MONTGOMERY COUNTY HISTORIC PRESERVATION COMMISSION
STAFF REPORT

Address:	7823 Overhill Rd., Bethesda	Meeting Date:	3/24/2021
Resource:	Contributing Resource Greenwich Forest Historic District	Report Date:	3/17/2021
Applicant:	Stephen Smith Randall Mars, Architect	Public Notice:	3/10/2021
Review:	HAWP	Tax Credit:	n/a
Permit No.:	944150	Staff:	Dan Bruechert
Proposal:	Building Addition and Accessory Structure Construction

Historic Preservation Committee Response

7823 Overhill Road

Historic Review . Back Elevation, Facing EAST

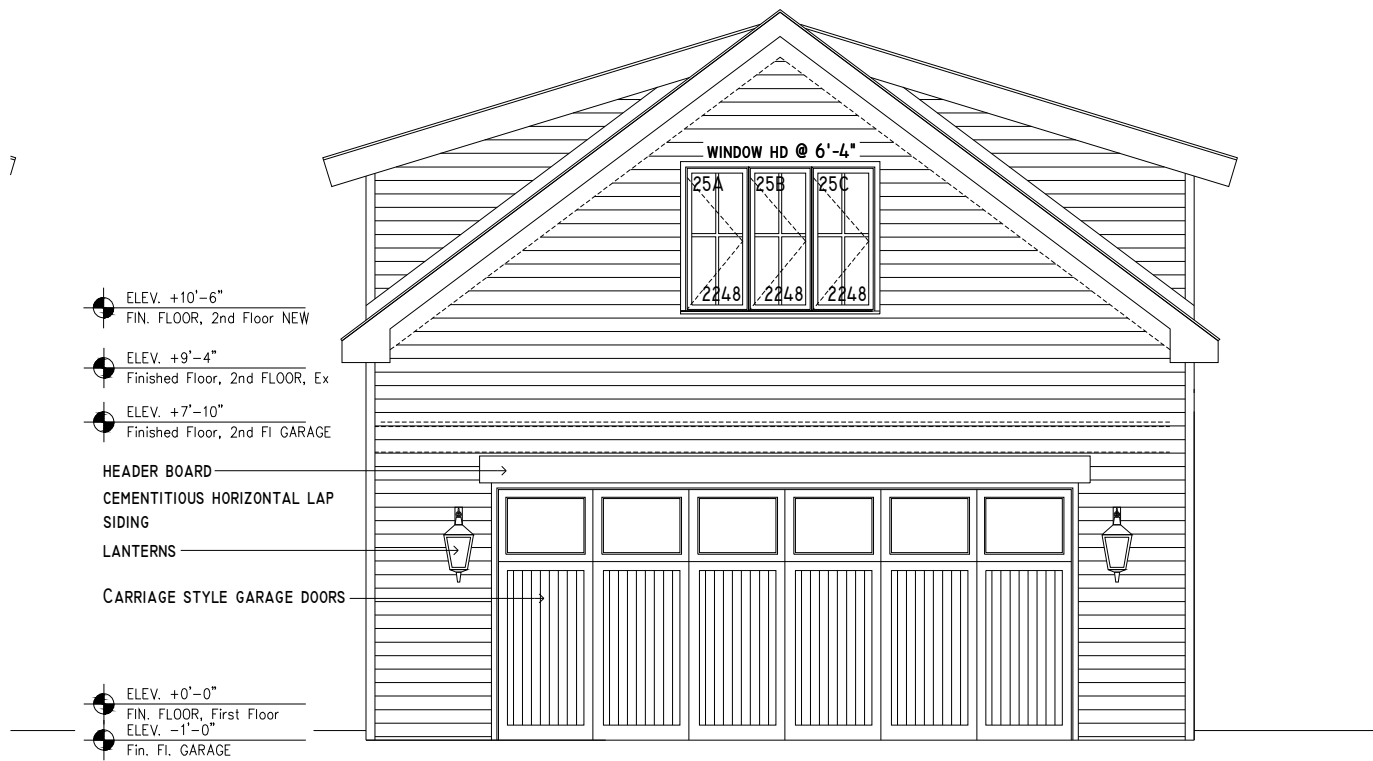
- Finally, the brick loggia or **colonnade**, with arched openings in the back, was questioned regarding its appropriateness. This architectural element draws precedence from Jefferson's designs for *Poplar Forest* (1806) and the *Academical Village* (1817). The element reduces the apparent mass of the primary addition, bringing the scale down to a single story, while creating a shaded area for use by the owner.

Elevations @ Garage

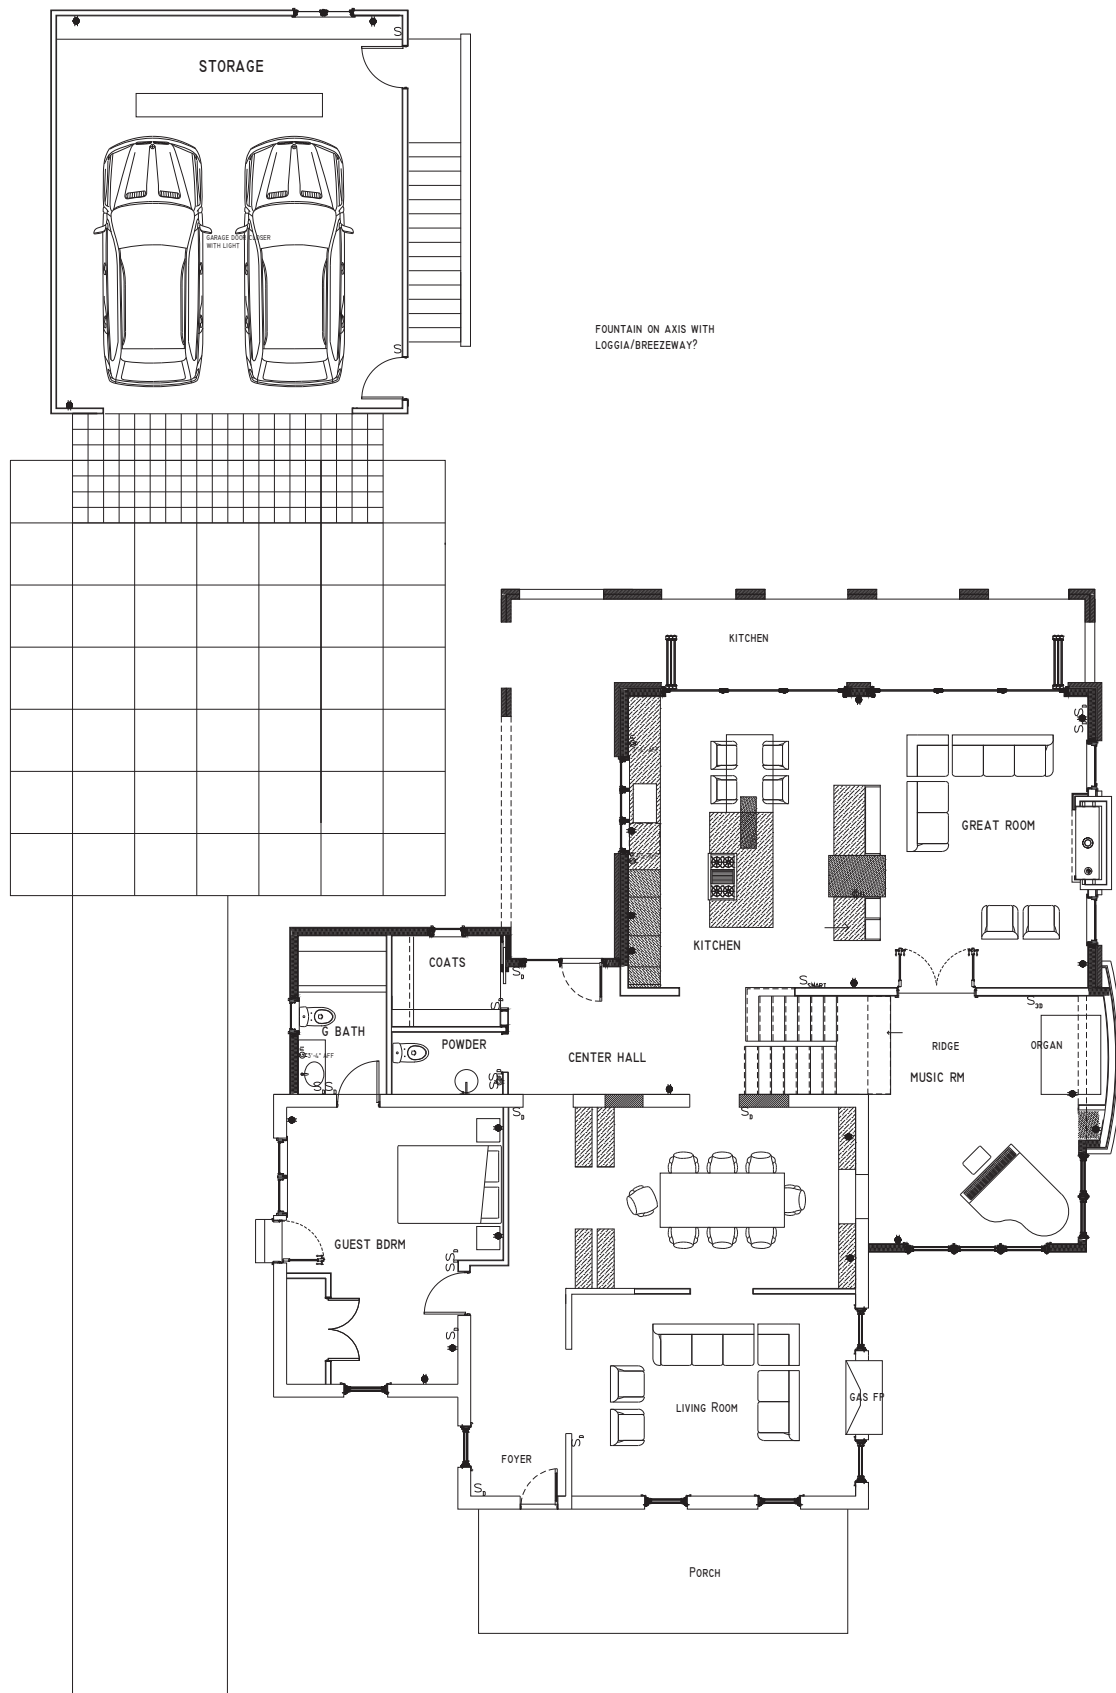
The existing one-car garage will be enclosed and integrated as living space as part of the proposed new construction. In the northwest corner of the lot, the applicant proposes to construct a two-car garage with office space above. The garage measure approximately 23' × 26' (twenty-three feet by twenty-six feet), which is 5% of the lot, with a front gable roof and an exterior staircase to the second floor. The design of the garage utilizes wall dormers to decrease the apparent mass of the structure. The exterior of the garage will be clad in fiber cement siding with architectural shingles on the roof. The vehicle doors will be carriage-style wood doors.

Staff finds the size of the garage is compatible with the *Design Guidelines* (B5), which allows accessory structures up to 7% of the lot coverage when the house is less than 25%. Staff finds that the height and massing, while large, is similar to the garage constructed at 7828 Hampden Rd. (shown below), which measures 22' 8" × 27' (twenty-two feet, eight inches by twenty-seven feet). Staff finds the materials for
